Programmatic
Environmental Impact Statement
related to decontamination and disposal
of radioactive wastes resulting from
March 28, 1979 accident
Three Mile Island Nuclear Station, Unit 2

Docket No. 50-320

Final Supplement Dealing with
Post-Defueling Monitored Storage
and Subsequent Cleanup

August 1989

FIGURE 2.4. Map of the General Area Exposure Rates 4 to 7 Feet (1.2 to 2.1 Meters) Above the 282-Foot Elevation During May 1989, in R/h for Gamma Radiation

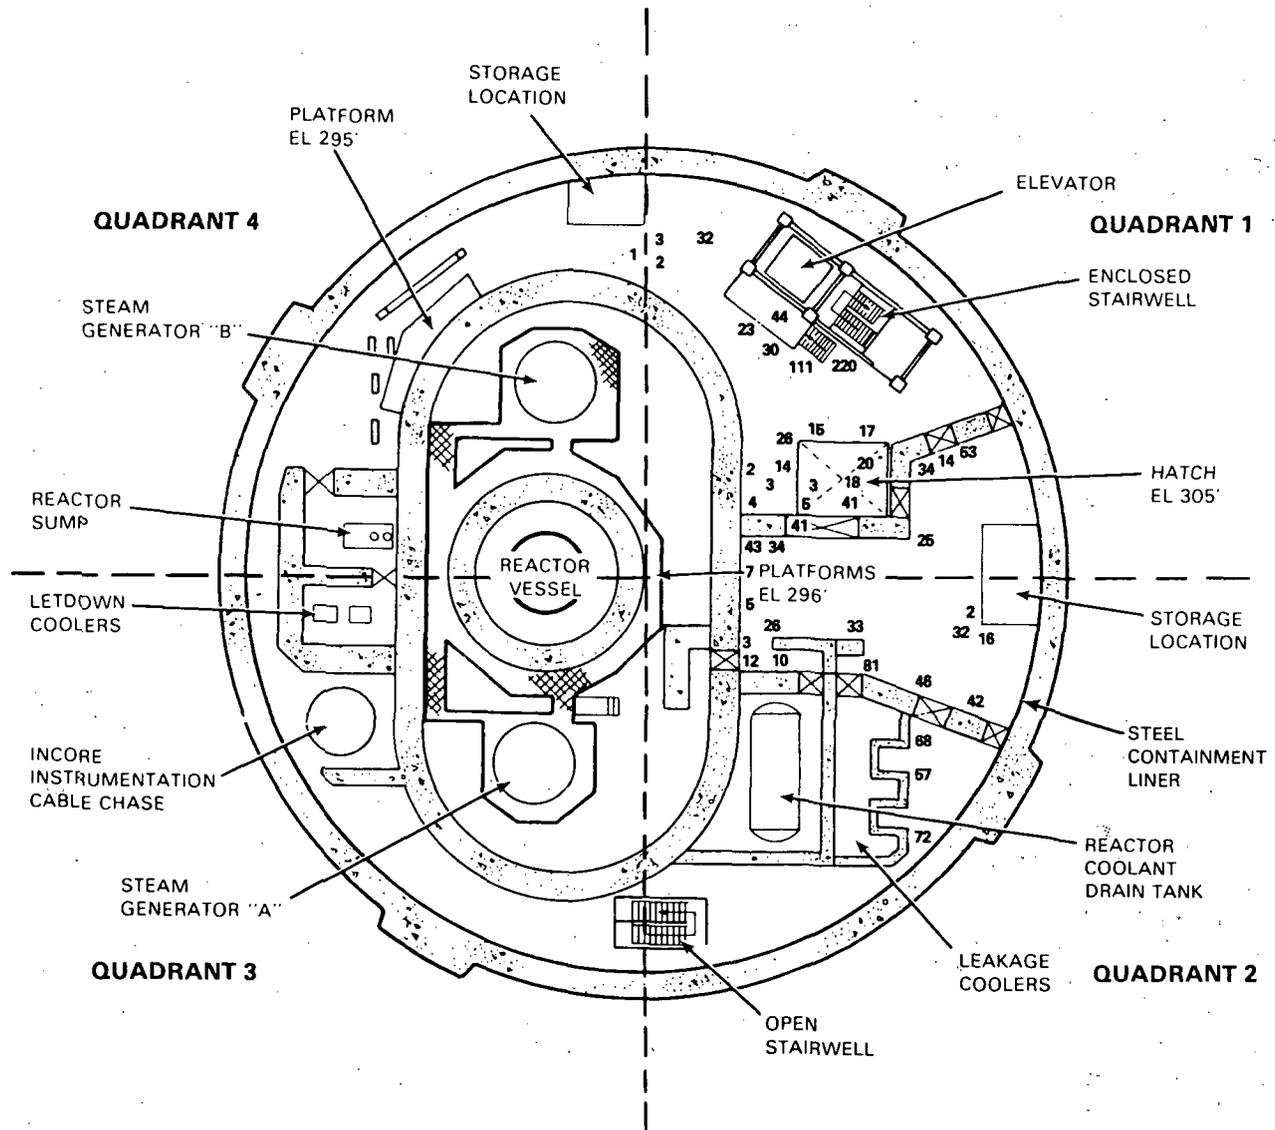
- 2.1.1 Page 2.12/Figure 2.7 - The data presented in this figure should be clarified. The radiation exposure rates are not general area exposure rates but rather are exposure rates obtained by use of a shielded directional probe. Most of the data is derived from contact readings. Even the general area readings are highly directional and do not give an accurate representation of actual general area exposure rates. Thus, the actual general area exposure rates, taken with a non-directional probe, would be lower than the contact exposures rates but higher than the general area exposure rates identified on this figure.

A map of the radiation exposure rates in the basement during May 1989 is shown in Figure 2.4. Most of the data in this figure were obtained from contact readings (all measurements were made with a shielded directional probe). The radiation levels in the basement vary somewhat with elevation. This map represents conditions 4 to 7 feet (1.2 to 2.1 meters) above the floor of the basement. General area radiation exposure rates taken with a nondirectional probe would be lower than the contact exposure rates, but higher than the general area exposure rates identified in Figure 2.4. The highest measured radiation exposure rates (400 R/h to 1100 R/h before decontamination) in the reactor building basement were in the vicinity of the elevator shaft and enclosed stairwell. These structures, which are made of hollow concrete blocks, became saturated with the accident-generated water and absorbed radionuclides from the water. Analyses of core samples of the concrete block indicate that the contamination (primarily cesium-137) has completely penetrated the concrete block. Analyses of core samples from the concrete walls indicate that approximately 90 percent of the radioactivity (primarily cesium-137) in the concrete walls and the D-ring walls is within the first 1/8 inch (0.3 centimeter) to 1/4 inch (0.6 centimeter) of concrete.
